SB, ELECTRICAL SYSTEM UPDATE, DE-LINE, 2025-07

New features and improvements of the DE 130 H electric system are implemented on the already existing DE-Line.

Grounding Cable

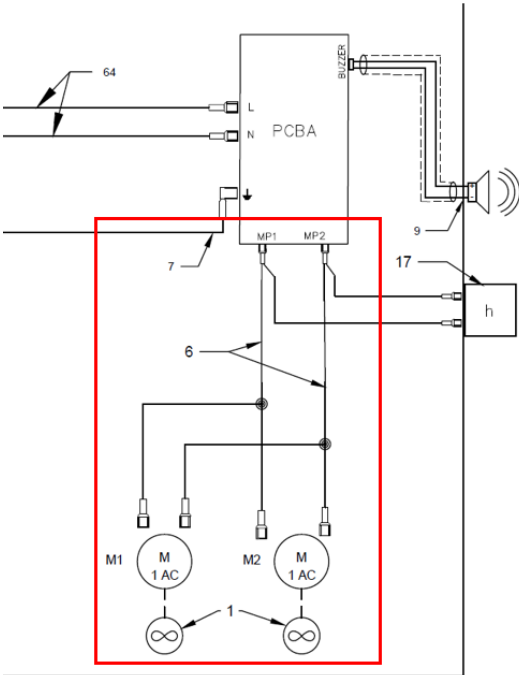
Old		New	Affected Variants	Explanations of Changes
529620802	>	529620801	DE 120 H NA, 120 V DE 120 H NA, 230 V DE 130 H NA, 120 V DE 130 H NA, 230 V DE 110 S NA, 120 V DE 110 H NA, 120 V	The same cable as used in the rest of the variants will now be used for NA-variants. Thicker cable and green/yellow colored. Updated crimping.

Wire

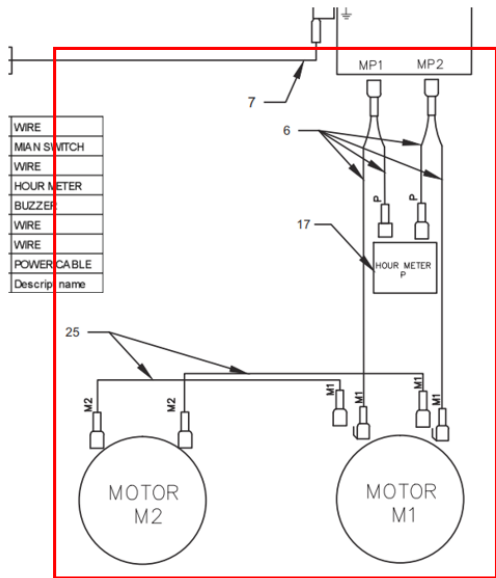
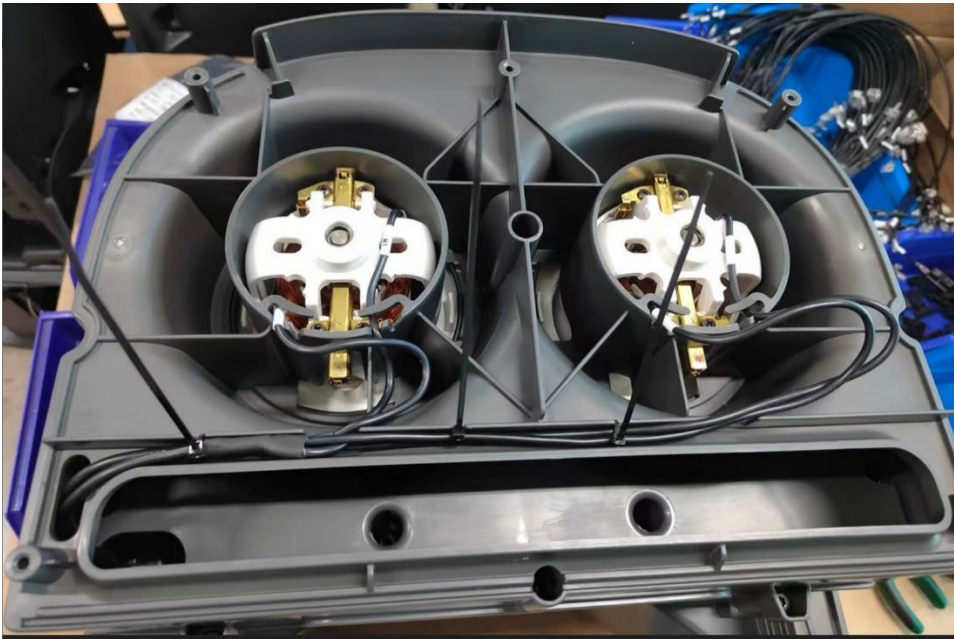
Old		New	Affected Variants	Explanations of Changes
536481301	>	547044201	All variants of DE 120 H	Previously two motor cables are now combined to one.

New motor cable schematic.

Old motor cables schematic.

Motor cables are routed as picture. Make sure the splice fits inside the groove.
